Source: SA5 (Telecom Management)
Title: Rel-4 CR 32.111-2 (Fault Management; Alarm IRP IS)
Document for: Decision
Agenda Item: 7.5.3

⌘ **32.111-2 CR 030** ⌘ rev - ⌘ Current version: **4.6.0** ⌘

Title:	⌘ Incorrect alarm interface class diagram		
Source:	⌘ SA5 (mohanr@lucent.com)		
Work item code:	⌘ OAM-FM	Date:	⌘ 14/05/2004
Category:	⌘ F	Release:	⌘ Rel-4
	<i>Use one of the following categories:</i> F (correction) A (corresponds to a correction in an earlier release) B (addition of feature), C (functional modification of feature) D (editorial modification) Detailed explanations of the above categories can be found in 3GPP TR 21.900 .		<i>Use one of the following releases:</i> 2 (GSM Phase 2) R96 (Release 1996) R97 (Release 1997) R98 (Release 1998) R99 (Release 1999) Rel-4 (Release 4) Rel-5 (Release 5) Rel-6 (Release 6)

6.1 Class diagram

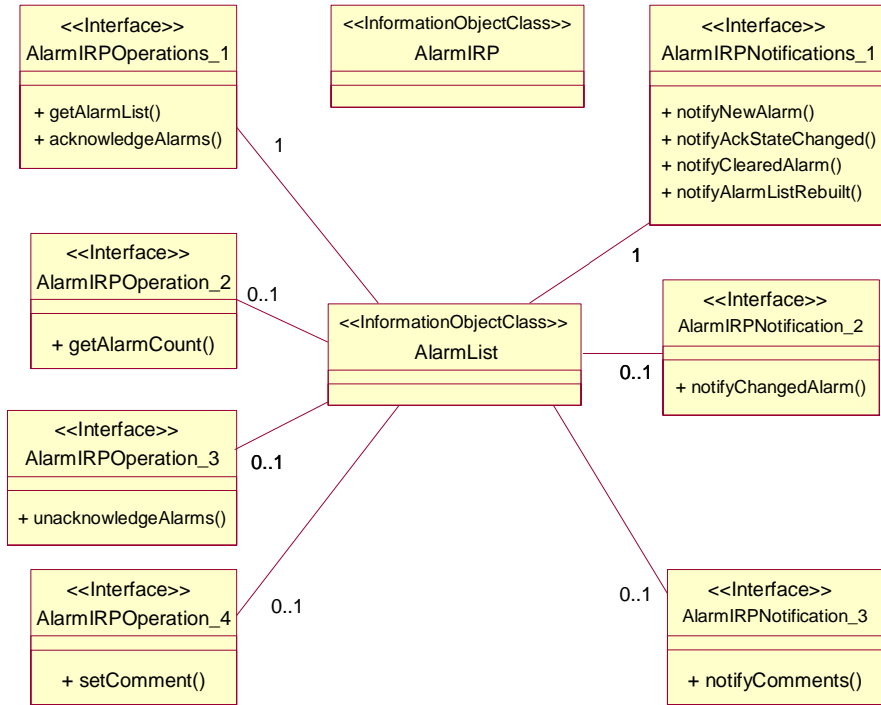
Reason for change:	⌘ Interface AlarmIRPNotification_4 was deleted from TS 32.111-2 v430 via SP-020474 (TSGS#17). This CR did request a change in the diagram, but the change in diagram did not get implemented for some unknown reason. The current CR is to request a re-implmentation of the same.
Summary of change:	⌘ Replace the current interface class diagram with the one originally present in v4.1.0. This diagram does not have Interface AlarmIRPNotification_4.
Consequences if not approved:	⌘ <ul style="list-style-type: none"> An interface class diagram that shows the presence of a notification and does not have any supporting documentation (in the IS & SS) pertains to incomplete specification. Besides, it also means that Interface AlarmIRPNotification_4 exists in Rel-4 (as a functionality). This could lead to vendors coming up with their own implementation of this interface and claiming compliance to Rel-4 Alarm IRP.

Change in Clause 6.1
